Accessibility Survey

City of Downey Quill Drive & Old River School Road

Date of Inspection
4/11/2017

Prepared By
Disability Access Consultants
(800) 743-7067

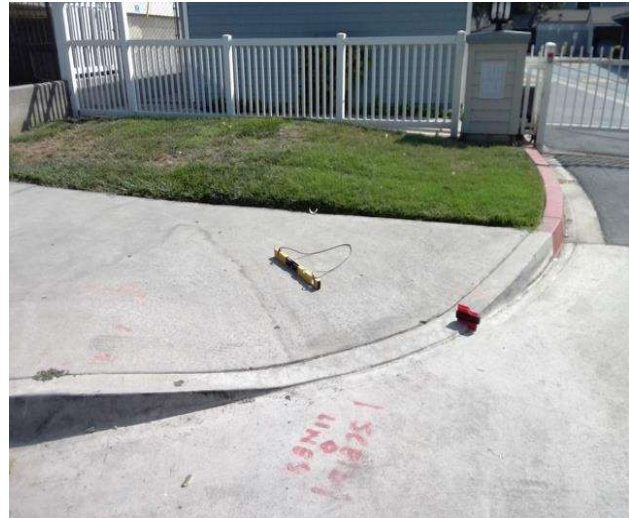
The curb ramp does not provide a detectable warning surface which includes truncated domes.

On-Site Finding Not Found

Provide compliant detectable warnings to surface.

Change In Level West Of Rives Avenue @ 33.929544083287, -118.155378699303

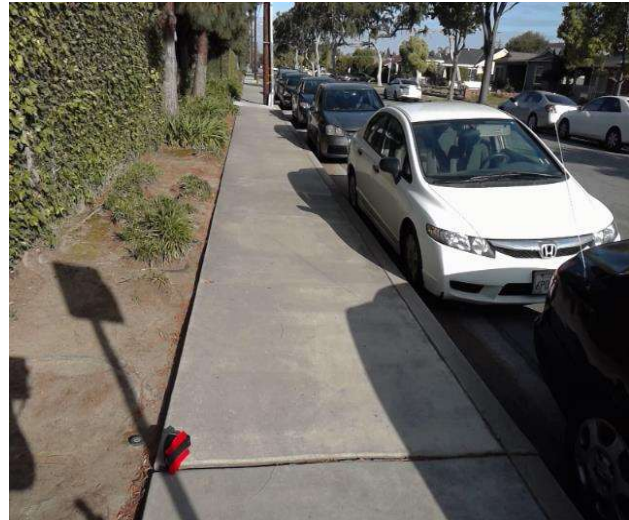
There is a change in elevation greater than recommended value.

On-Site Finding 0.75 inches

Ensure that the change in elevation is within the recommended value.

Change In Level West Of Rives Avenue @ 33.929638666761, -118.155510127544

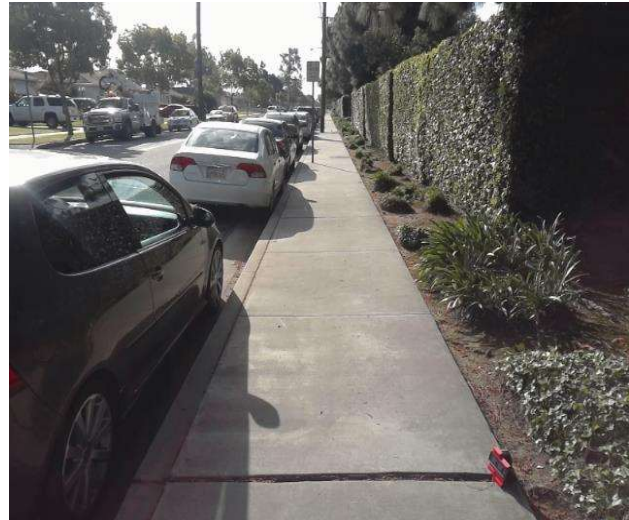
There is a change in elevation greater than recommended value.

On-Site Finding 0.62 inches

Ensure that the change in elevation is within the recommended value.

Change In Level West Of Rives Avenue @ 33.930162768578, -118.156552165747

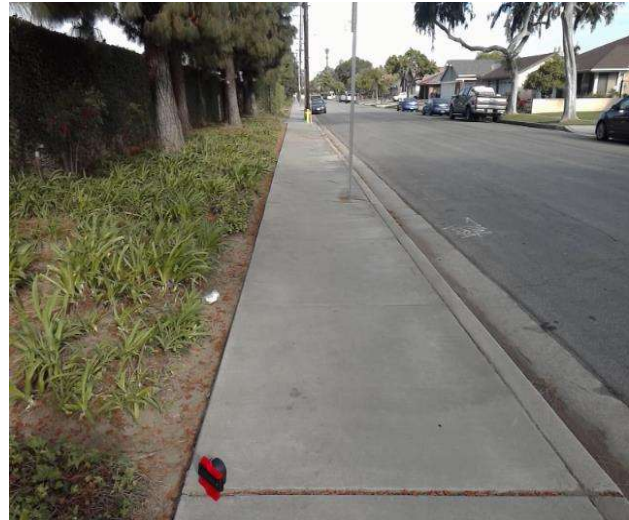
There is a change in elevation greater than recommended value.

On-Site Finding 0.50 inches

Ensure that the change in elevation is within the recommended value.

Change In Level West Of Rives Avenue @ 33.930225081956, -118.156678229570

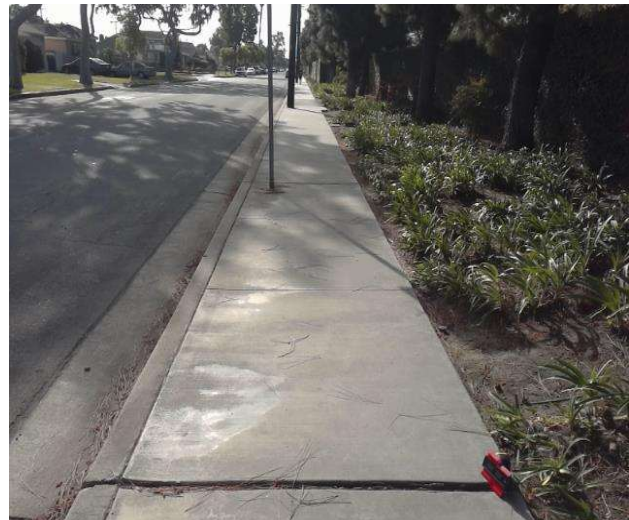
There is a change in elevation greater than recommended value.

On-Site Finding 0.50 inches

Ensure that the change in elevation is within the recommended value.

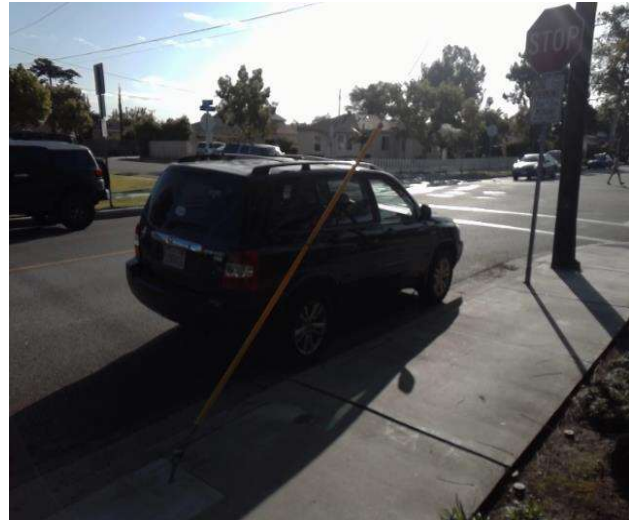
Overhead obstruction height is not compliant.

On-Site Finding 65.00 inches

Provide a compliant vertical clearance height.

Change In Level East Of Rives Avenue @ 33.928806328584, -118.153526633978

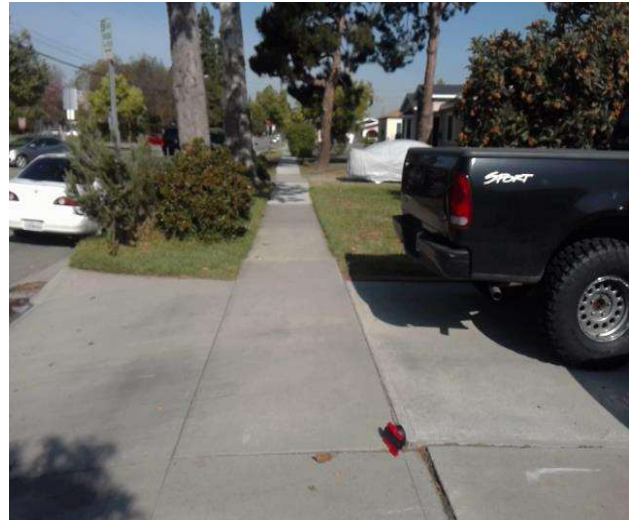
There is a change in elevation greater than recommended value.

On-Site Finding 0.62 inches

Ensure that the change in elevation is within the recommended value.

Change In Level West Of Morning Avenue @ 33.928828583721, -118.153915554285

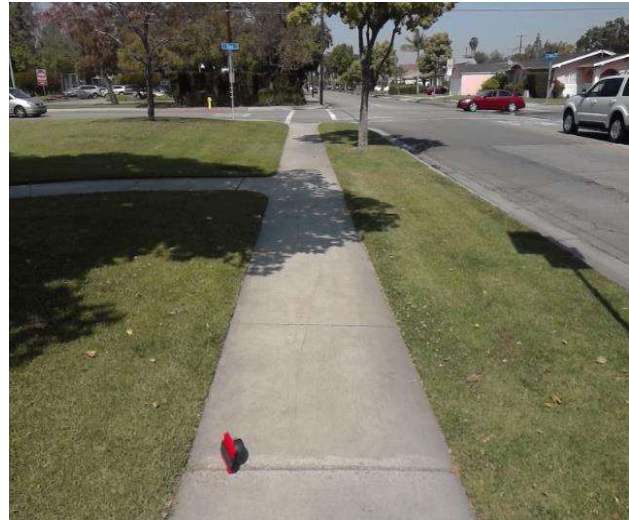
There is a change in elevation greater than recommended value.

On-Site Finding 0.37 inches

Ensure that the change in elevation is within the recommended value.

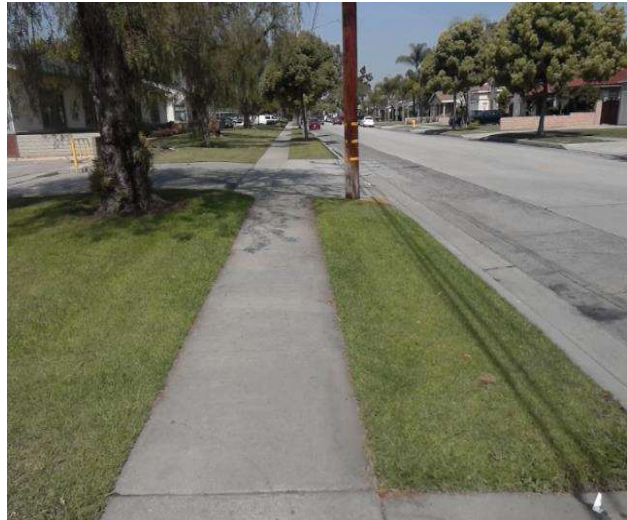
Sidewalk cross slope is not compliant.

On-Site Finding 4.70 percent for 360.00 feet

Repave the sidewalk surface with the recommended cross slope.

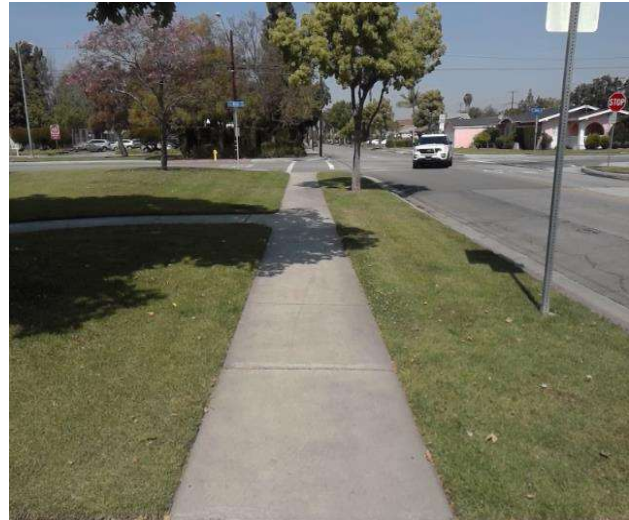
Sidewalk cross slope is not compliant.

On-Site Finding 3.70 percent for 23.00 feet

Repave the sidewalk surface with the recommended cross slope.
